Subject: Duke Energy Carolinas, LLC
William States Lee III Nuclear Station - Docket Nos. 52-018 and 52-019
AP1000 Combined License Application for the William States Lee III Nuclear
Station Units 1 and 2
Response to Request for Additional Information Letter No. 120 (eRAI 7570)
Ltr#: WLG2014.08-01

Reference: Letter from Brian Hughes (NRC) to Robert Kitchen (Duke Energy), Request
for Additional Information Letter No. 120, Related to SRP Section 03.07.02 –
Seismic System Analysis for the William States Lee III Units 1 and 2
Combined License Application, dated July 11, 2014 (ML14192B073)

RAI 03.07.02-3 (eRAI 7570)

Reference NRC RAI Number(s): 03.07.02-3 (eRAI 7570)

Figure 03.07.02-3-7 - Reactor Coolant Pump

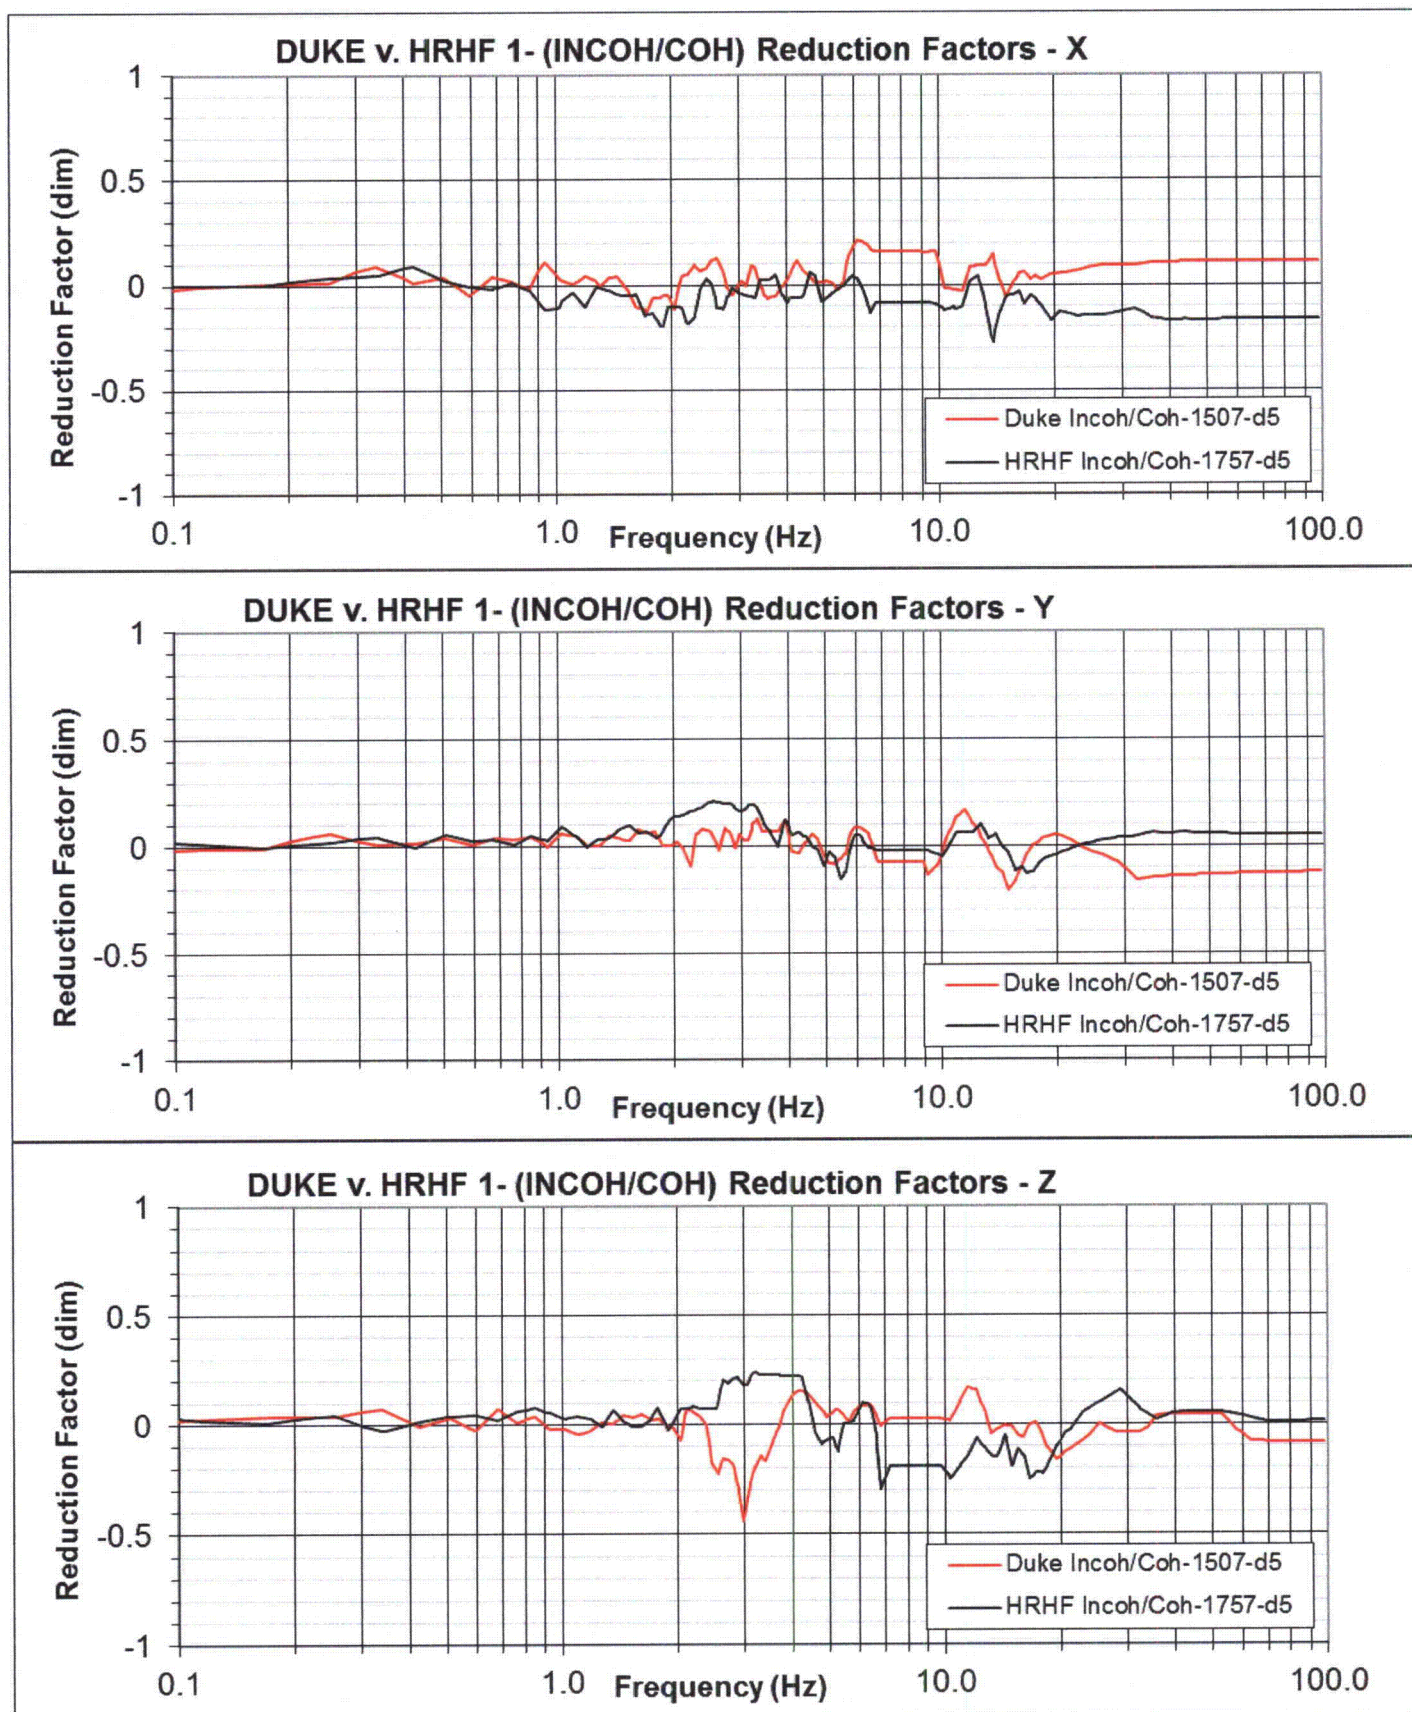
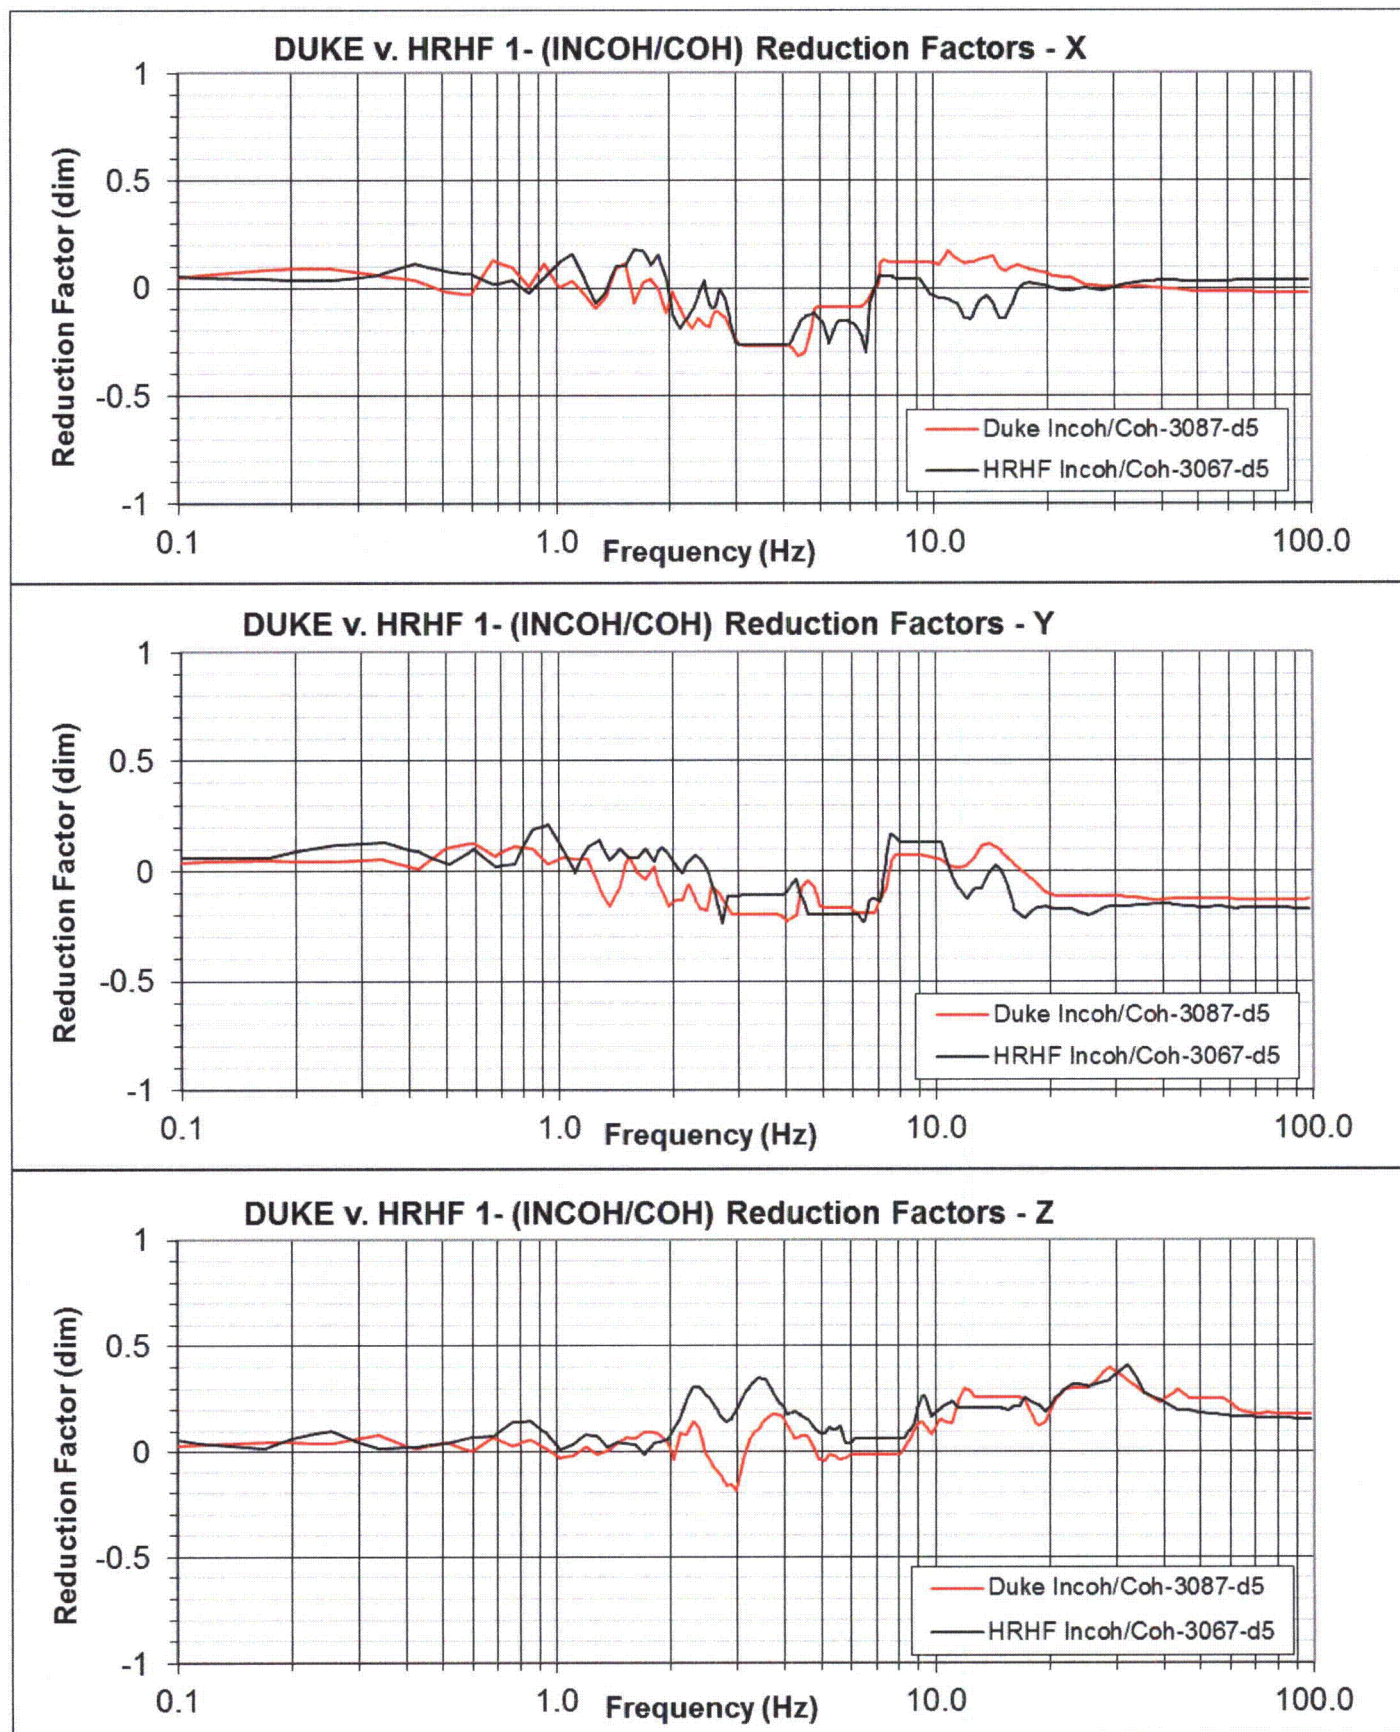
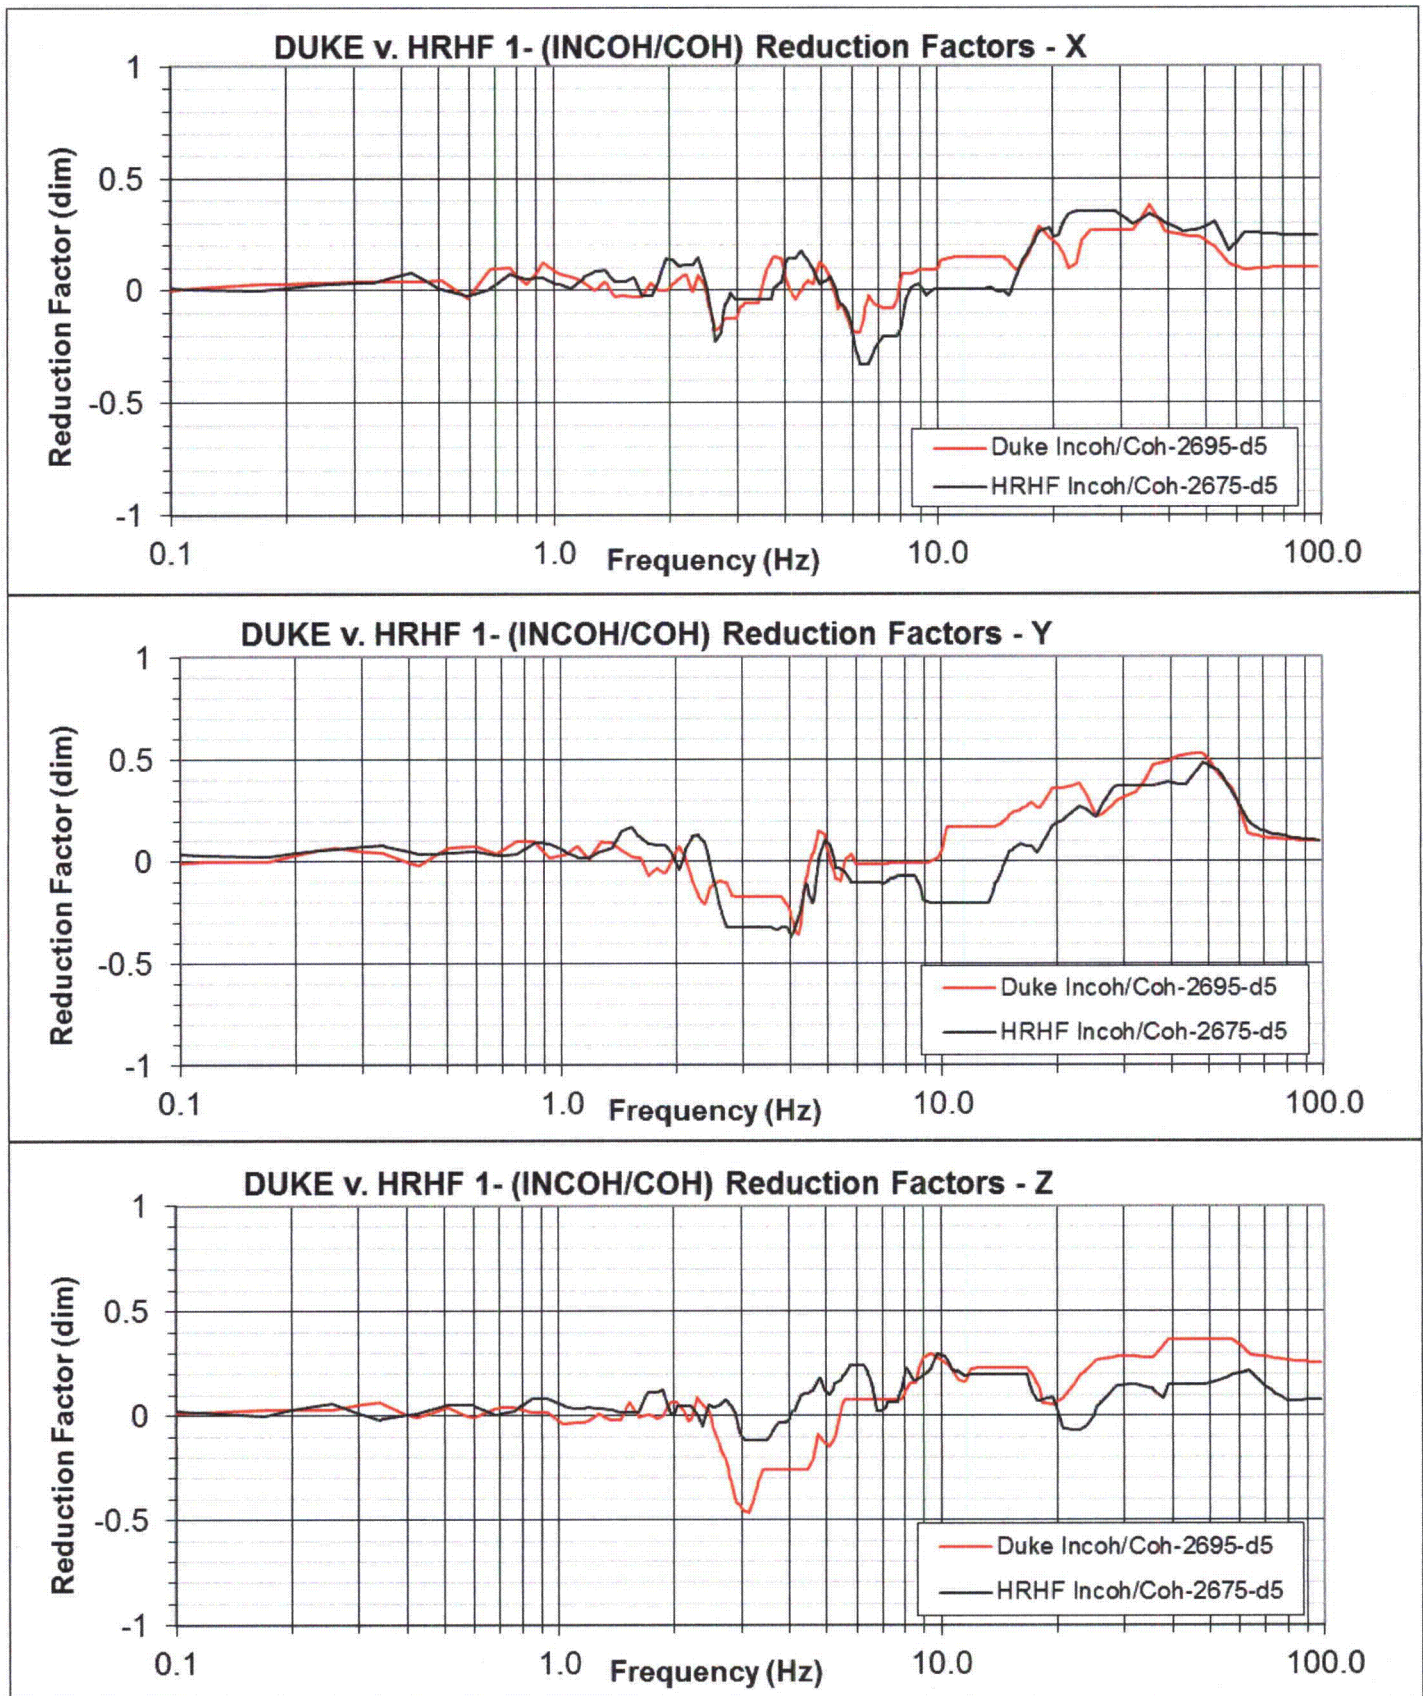
Staff review of Duke Ltr#WLG2014.01-02 Appendix A to WLG-GW-GLR-815 Rev 0 finds that while the graphical comparisons are helpful in assessing the impacted frequency ranges due to incoherency, they do not indicate the percentage reduction of coherent motion; $[1 - (\text{incoherent response} / \text{coherent response})] \times 100\%$.

To assist the staff in its review of the site-specific implementation of seismic motion incoherency, the applicant is requested to quantify the range of reductions to coherent motion for both the AP1000 HRHF and site-specific evaluations.

The following summarizes the data presented below in Figures 03.07.02-3-1 through 03.07.02-3-9:

- The Duke Lee and AP1000 TR115 FRS coherent reductions are comparable for the NI nodes and directional FRS presented. Reduction factors trend similarly in shape and magnitude, and reduction factor differences, both positive and negative occur for both Duke Lee and AP1000;
- Duke Lee and AP1000 TR115 FRS incoherent reduction factor differences are influenced by model refinements to the NI20u finite element model for Duke Lee versus the AP1000 NI20r model to reflect the latest design; and;

- Rock profile differences between the AP1000 generic hard rock profile and the site-specific Duke Lee concrete/rock profiles, i.e., lower shear wave velocity (V_s) in the 50' below basemat.

In conclusion, the Duke Lee and TR115 FRS coherent reductions are similar given the variations in Duke Lee versus AP1000 site conditions and the seismic model updates.

Figure 03.07.02-5-1 Valve Accelerations Time History With and Without Gaps for HRHF Seismic Input – ADS 4th Stage East Compartment Piping System

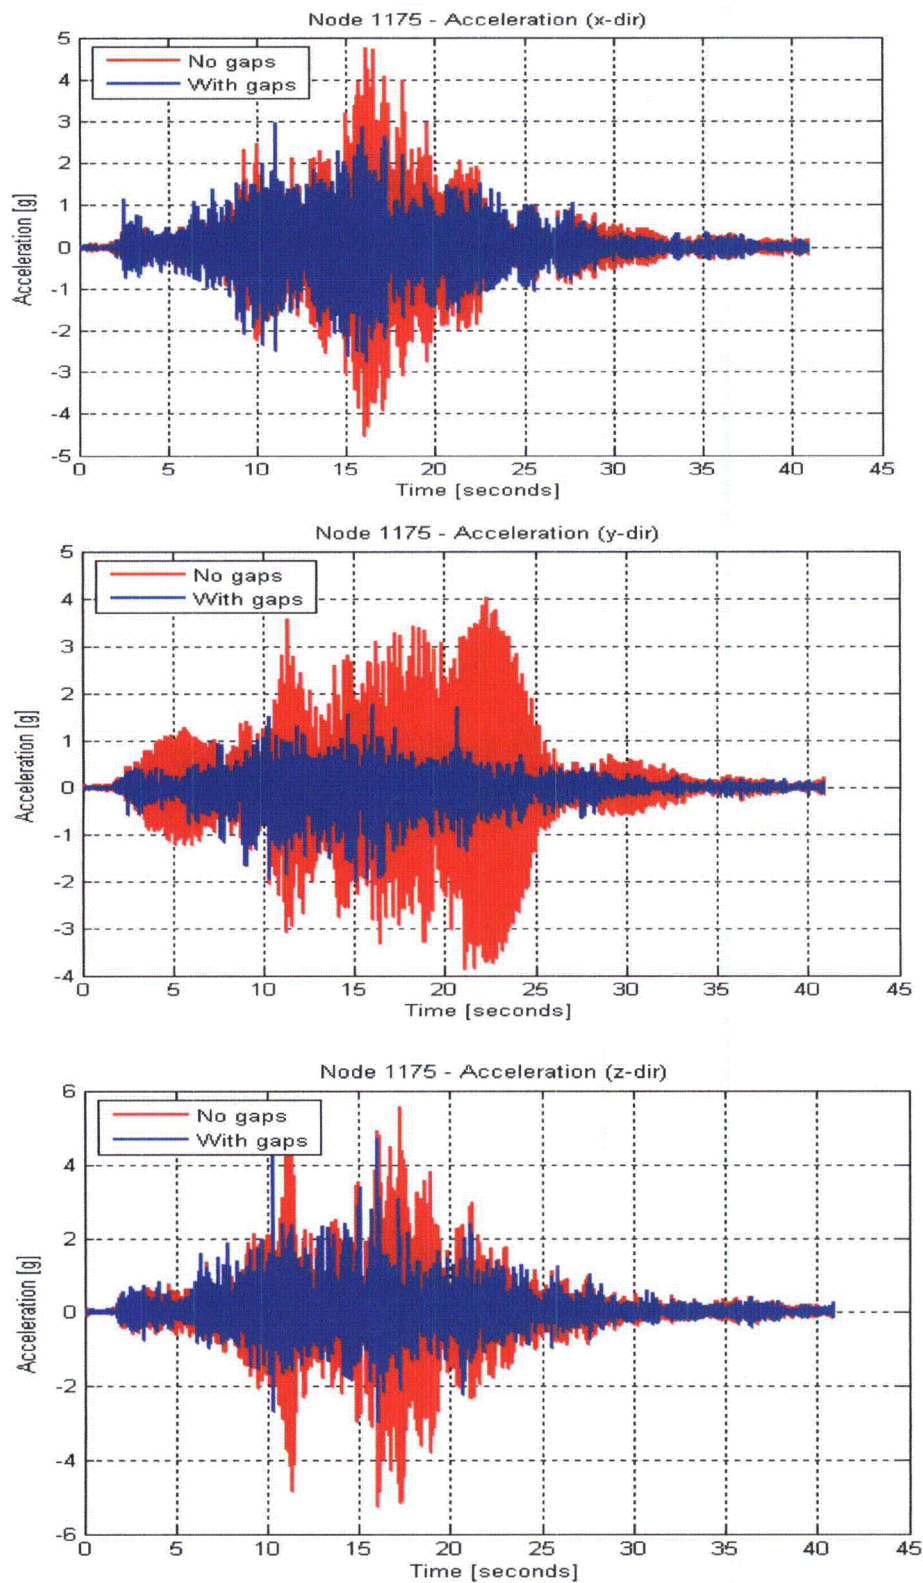
WLS FSAR (Rev. 8) Section 3.7.2.15 states that stresses resulting from site-specific high frequency input are bounded by AP1000 design basis analysis results and the effect of site-specific high frequency input on piping is non-damaging. Further, Section 3.7.2.15 states that although some of the site-specific ISRS exhibit minor exceedances of the comparable standard AP1000 equipment qualification RRS, in all cases the actual TRS used in completed testing exceed the site-specific demands by a significant margin. To assist the staff in its evaluation of the effect of high frequency input to piping and equipment, the applicant is requested to provide a discussion on sources of conservatism in piping analysis and equipment testing. Further, the applicant is requested to provide an estimate of the range of the seismic margin associated with piping analysis and equipment testing.

The influence of support gaps on the response of a piping system when subjected to a seismic high-frequency load was investigated through the study of a representative piping configuration located inside the containment building of the AP1000 nuclear power plant. The inside-containment Automatic Depressurization System (ADS) 4th Stage East Compartment piping system is potentially susceptible to high-frequency content excitation, having modes and natural frequencies in the high frequency range and being located so that the HRHF FRS exceeds the FRS from the AP1000 CSDRS in the high frequency range. The response from a nonlinear model including gaps in the supports was compared to the response from a linear model with rigid supports. Valve accelerations were evaluated and are shown in Figure 03.07.02-5-1 below. Pipe stresses for two different elements for both the CSDRS and HRHF seismic conditions are shown in Figures 03.07.02-5-2 and 03.07.02-5-3 below. As shown, both the valve accelerations and pipe stresses were lowered when gaps are considered. Therefore, considering the support gaps in the analyses influences the response of the piping system, and represents a source of conservatism inherent in the current piping system analysis. Note, axial (X), tangential (Y) and vertical (Z) directions represent the orientation of the time history analysis results shown below.
